Our Case Number: ABP-317121-23

Re: BusConnects Swords to City Centre Bus Corridor Scheme
Swords to Dublin City Centre

Swords to City Centre Core Bus Corridor Scheme

Busconnects Observation

Figure 8.1: Modelled annual average NO_2 concentrations for 2015 ($\mu\text{g}/\text{m}^3$)

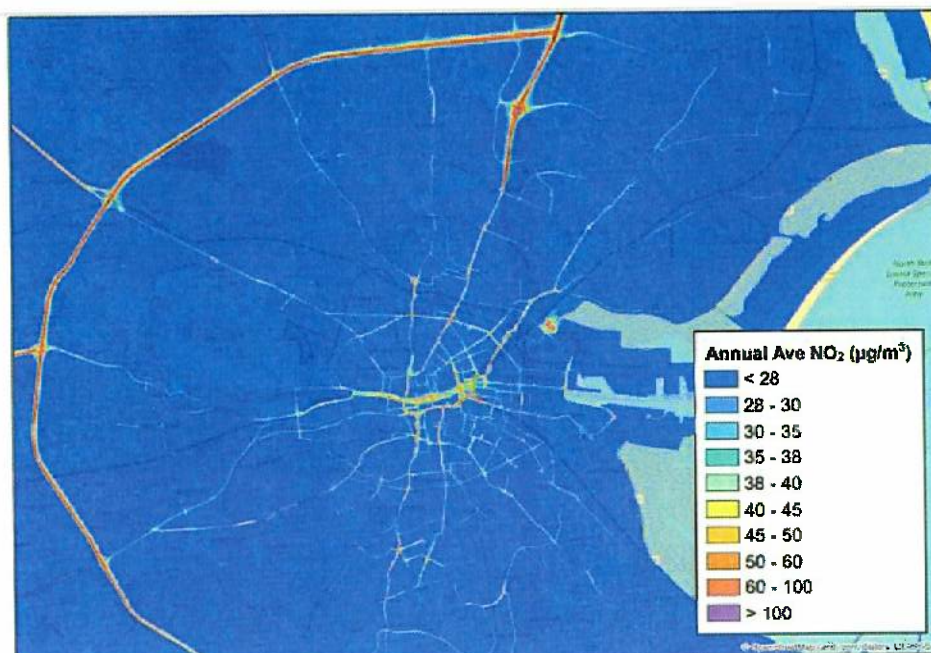
The proposed design is hostile to pedestrians, does not prioritise their movement, damages the public realm and unnecessarily creates extra private vehicle capacity. The remit of Busconnects does not include adding additional capacity for general private traffic and such a move goes against the Transport Strategy for the Greater Dublin Area (2022-2042). According to the EPA (Urban air quality modelling of Dublin Final report, 8th July 2019) this part of the Swords Road is one of the worst

areas in the city for air pollution, pollution caused by vehicular traffic. Inducing more traffic will further deteriorate air quality which goes against the stated aims of the Climate Action Plan (2023).
